Docket Item # 1
BAR CASE #2011-0244

BAR Meeting
September 21, 2011

ISSUE: Alterations (Brick Patio Wall & Gate)

LOCATION: 408 N Saint Asaph Street

Figure 1: Site Plan showing placement of existing fence/replacement wall.

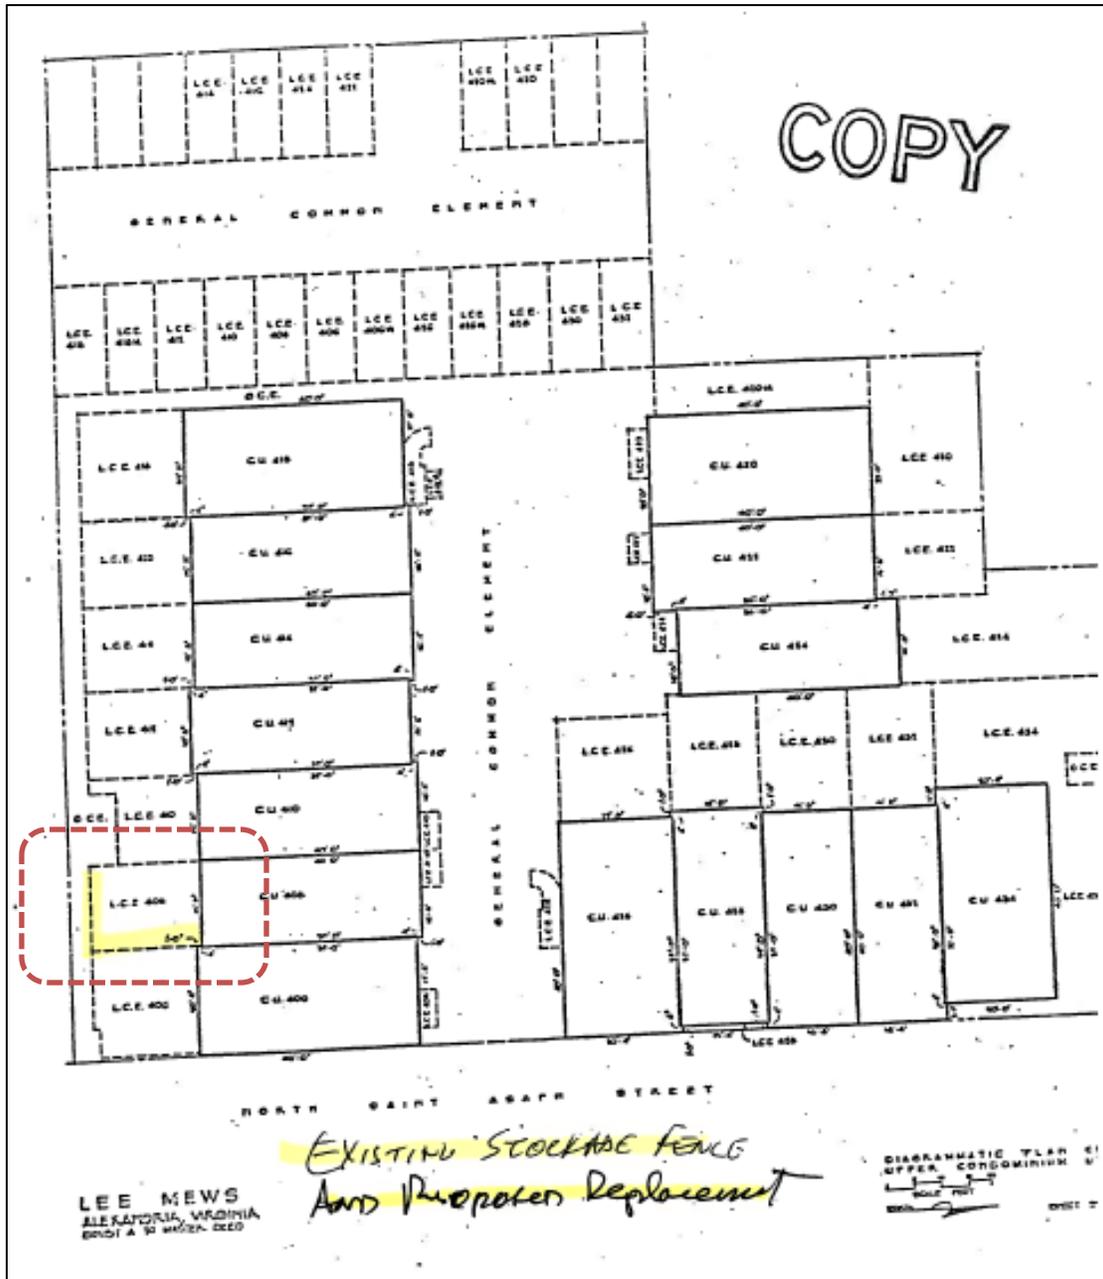
The applicant is requesting a Certificate of Appropriateness to remove the 6' high wood stockade fence along the south and east portion of the patio and replace it with a 5'6" high brick and wood wall and gate to match the brick and wood wall adjoining the property at 410 N Saint Asaph. The bottom two-thirds of the proposed wall will be laid in a running bond, capped with a single course of rowlock bricks. Above the rowlock bricks will be thin brick columns with a wood band running between them. The gate will be an arched brick opening with an arched wood door leading into the patio.

The wall will be located on the same footprint as the existing wood fence and join the adjacent neighbor's brick wall at 410 N Saint Asaph. The other side of the wall is a property line wall with 406 N Saint Asaph. Staff has received consent from the owners of 406 N Saint Asaph, as well as the Lee Mews Condominium Association, for the proposed alterations.

STAFF RECOMMENDATION: Staff recommends approval of the Certificate of Appropriateness, as submitted.
